**Docket A-98-49  
Item V-B2-1**

**COMPLIANCE APPLICATION REVIEW DOCUMENTS  
FOR THE CRITERIA FOR THE CERTIFICATION  
AND RECERTIFICATION OF THE  
WASTE ISOLATION PILOT PLANT'S  
COMPLIANCE WITH THE  
40 CFR PART 191 DISPOSAL REGULATIONS:  
FINAL RECERTIFICATION DECISION**

**U.S. Environmental Protection Agency  
Office of Radiation and Indoor Air  
Washington, D.C. 20460**

**March 2006**

**Figure 15-3. Locations of Culebra well tests.**

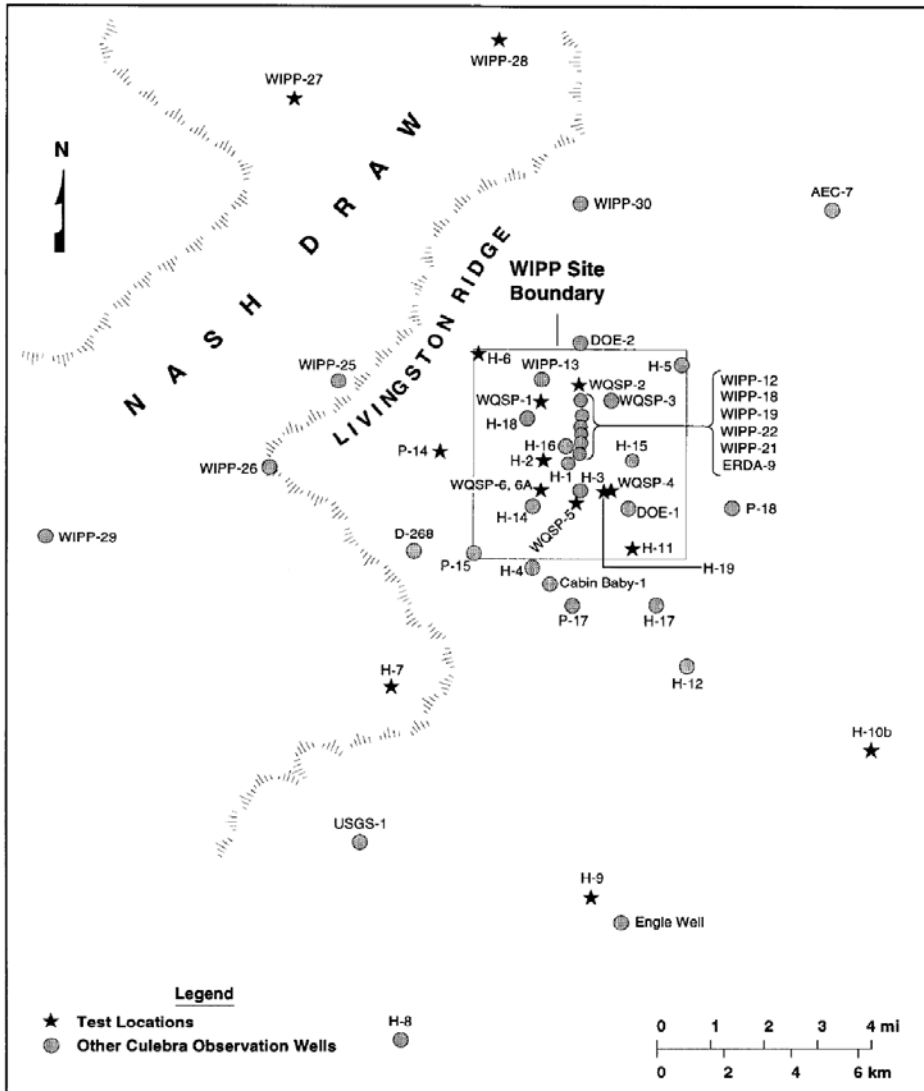
DOE has studied the WIPP site and vicinity for over thirty years (see Figure 15-3 for locations of Culebra well tests). New data is collected annually. In addition to the geologic studies, numerous pump test tests have been done, including large scale pumping tests (e.g., Beauheim and Ruskauff, 1998) and other analyses. DOE has provided these data and analysis results in the 2004 CRA and other reports. These data and their analyses provide information over large areas and form the basis for the performance assessment modeling and much of the discussion presented here. For example, in the 2004 CRA, DOE identified that the Culebra transmissivity is a function of overburden thickness—the deeper the Culebra, the lower the transmissivity (2004 CRA, Appendix PA, Attachment TFIELD). Superimposed on the depth are geologic factors such as the location relative to the margin of upper Salado dissolution and to halite in the M3/H3 interval of the Tamarisk.

The Magenta and Culebra appear to have little real-time connection to one another as claimed by some commenters. Numerous pumping tests show that the Magenta and Culebra are independent of one another (Beauheim and Ruskauff, 1998; Meigs et al, 2000; 2004 CRA Chapter 2, section 2.2.1.4.1.2). Pump tests in the Culebra elicit no response from the Magenta. Even at WIPP-25 in Nash Draw, a pumping test conducted in 2004 indicates that the Magenta and Culebra are hydraulically isolated from one another (Lorenz, 2005, p. 63). This is typical for all pump tests performed. In addition water chemistry differences also point to lack of connections between the two units.

**Figure 15-4. Four Hydrochemical Facies in the Culebra Siegel et al. 1991**

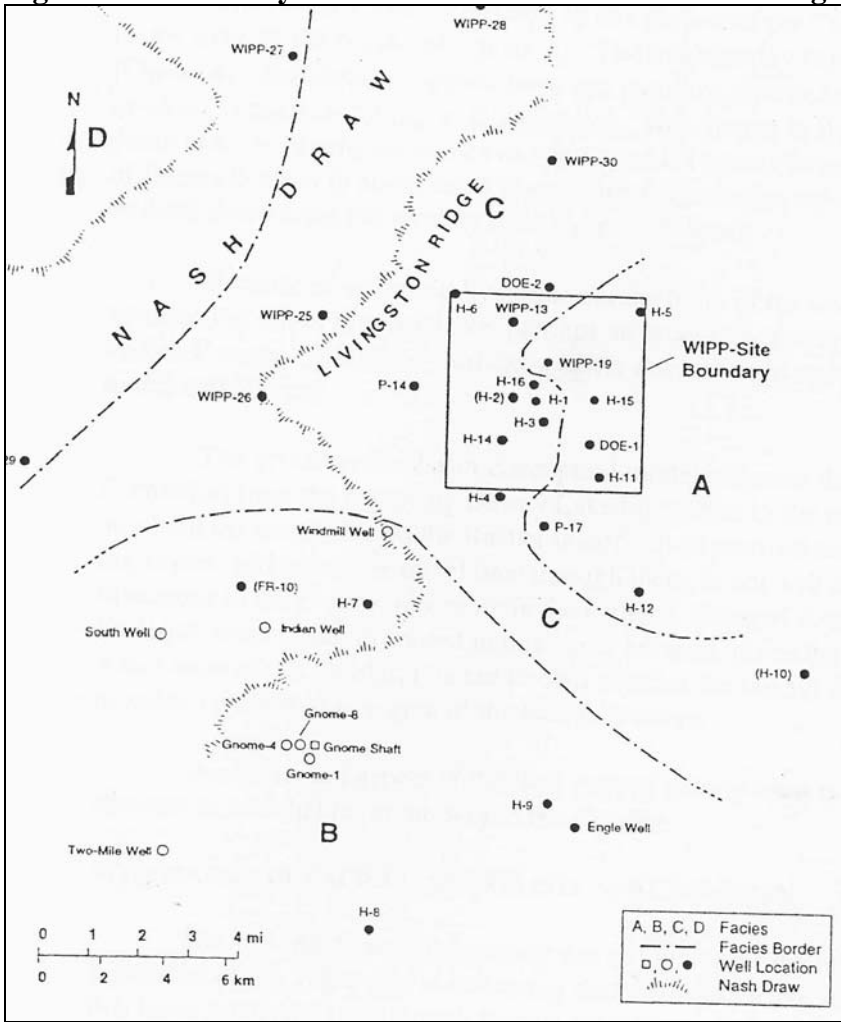
EPA believes that, on a regional scale, the groundwater basin model done by DOE reasonably predicts the current ground water flow regime and the geochemistry of the site.

EPA also reviewed the commenter’s allegations that a data point at the H-3 well had been falsified and led to an incorrect characterization of the Magenta Dolomite. Commenters stated that CCA, Appendix GCR (p. 6-53) indicated that the Magenta at well H-3 has high transmissivity that DOE does not account for in its modeling. Based on our understanding of the geohydrology in the area, evidence provided by DOE in its Magenta Transmissivity fact sheet and the raw data and graphs, and the fact that the CCA Appendix GCR data point is not confirmed by subsequent testing, EPA believes that the CCA Appendix GCR data point is an error. The remainder of the data indicates that the Magenta has generally low transmissivity—lower than the Culebra. The Magenta Dolomite has high transmissivity in Nash Draw, but the geologic processes that formed Nash Draw are different than what has transpired at the WIPP site. Thus, EPA still believes that the Culebra Dolomite is the more transmissive unit, and that it is appropriate to consider the Culebra Dolomite as providing the pathway that would lead to the most releases.

**Figure 34.1. Mean and Quantile CCDFs for Total Normalized Releases: All Replicates of the CRA-2004 PABC (from Figure 6-4, 2004 Compliance Recertification Application Performance Assessment Baseline Calculation, Docket A-98-49, Item B2-51)**

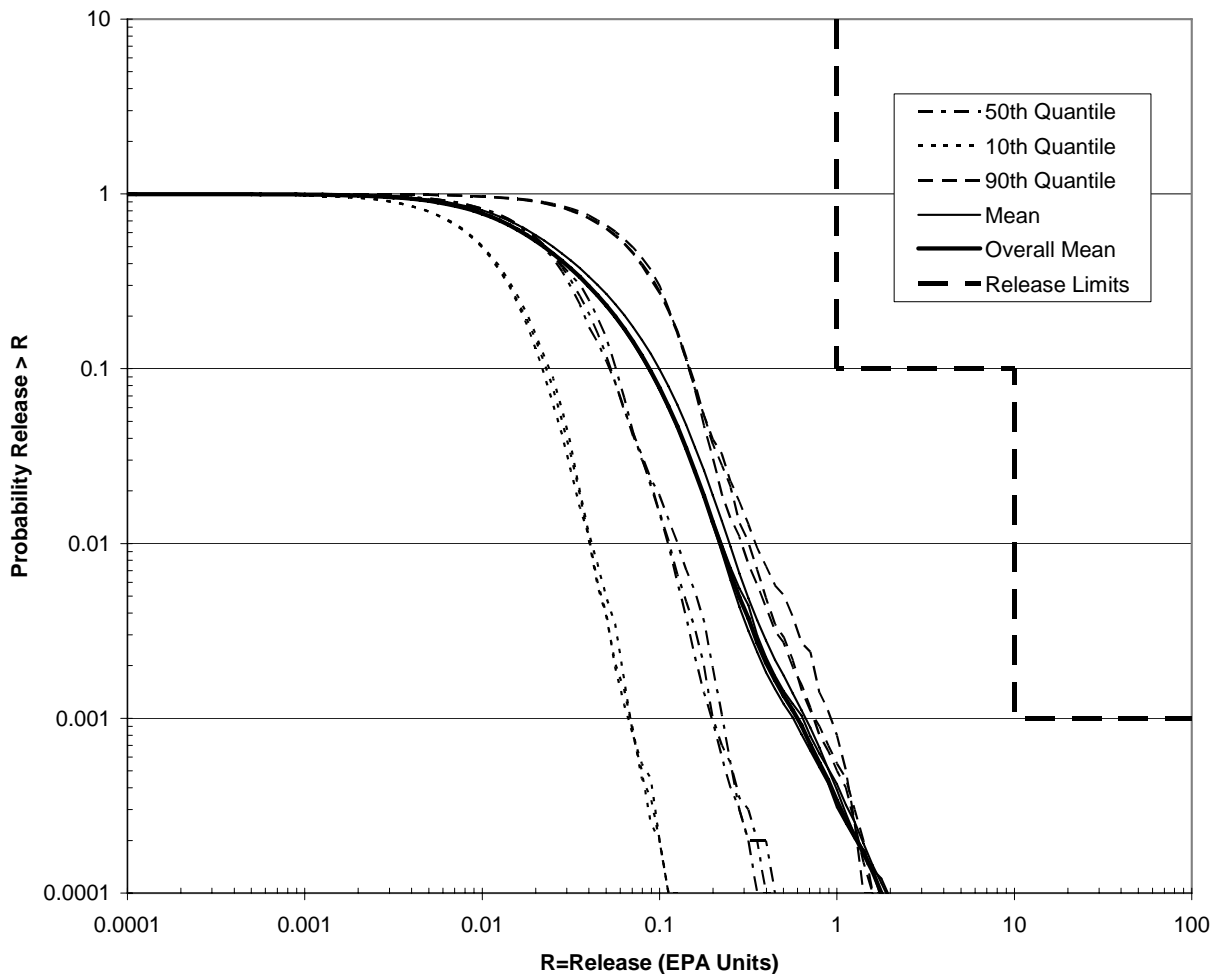
DOE used selected computer codes and input parameters to generate estimates of radionuclides for a large number of release scenarios. In total, 300 CCDFs (100 for each of the three replicates) were constructed and presented in the Performance Assessment Baseline Calculation Report (Docket A-98-49, Item II-B2-60) for total normalized releases (Figure 34-1). Three hundred realizations were needed in order to satisfy the requirements of Section 194.34(d). Normalized release results for ten thousand future simulations were used to calculate each of the 300 CCDF curves. In addition, DOE provided CCDFs for individual pathways and by replicate. EPA's analysis (Docket A-98-49, Item II-B1-16) concluded that DOE adequately presented the PA results in CCDFs, which show the probability of exceeding various levels of cumulative releases.

**Figure 34-2. Total Normalized Releases for 100 CCDFs of Replicate R1 of the CRA-2004 PABC (Figure 6-1, PABC Report, Docket A-98-49, Item II-B2-60).**

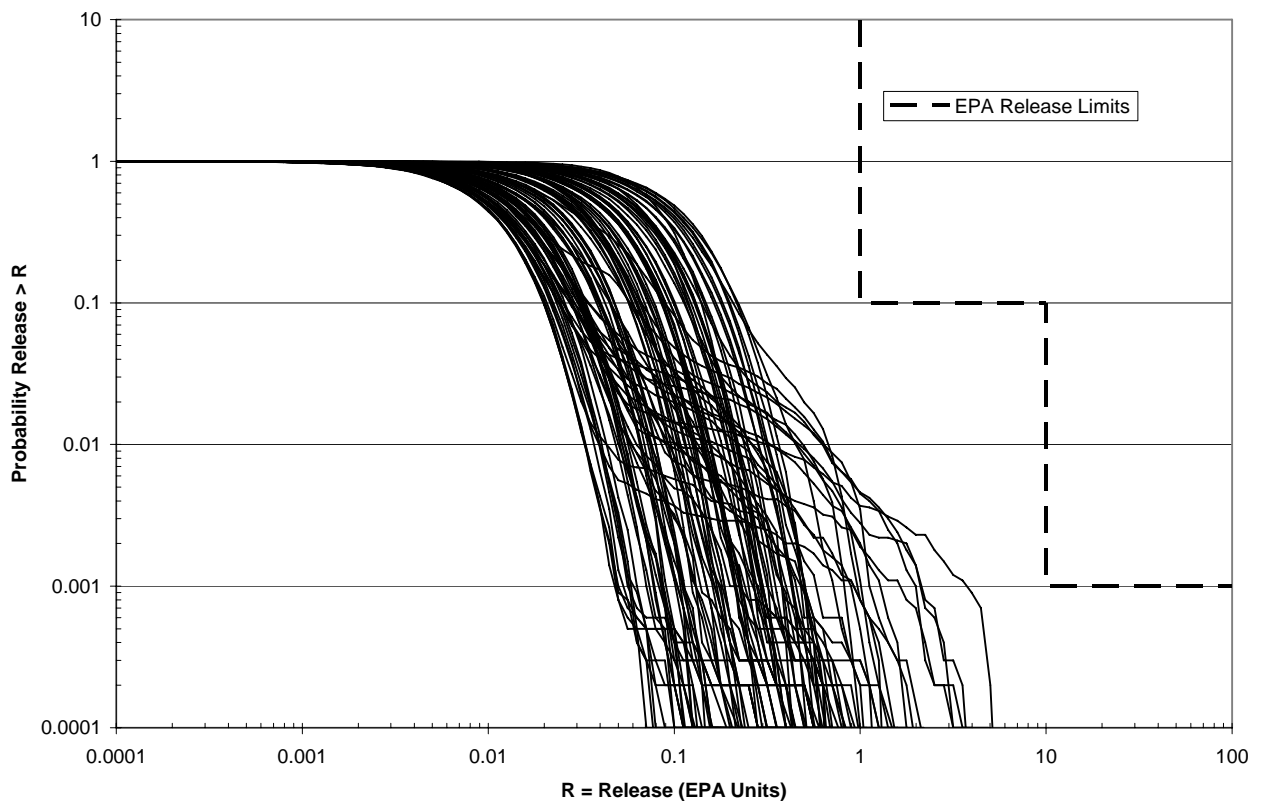
DOE presented and discussed the results of the performance assessment analysis in the 2004 CRA, Chapter 6 and the PABC report, Chapter 6 (Docket A-98-49, Item II-B2-60). Figure 34-2 shows the releases from replicate R1 of the CRA-2004 PABC.

Based on a review and evaluation of the 2004 CRA and supplemental information provided by DOE (FDMS Docket ID No. EPA-HQ-OAR-2004-0025, Air Docket A-98-49) and the fact that DOE included the full range of CCDFs as required by this section, EPA determines that DOE continues to comply with the requirements for Section 194.34(e).
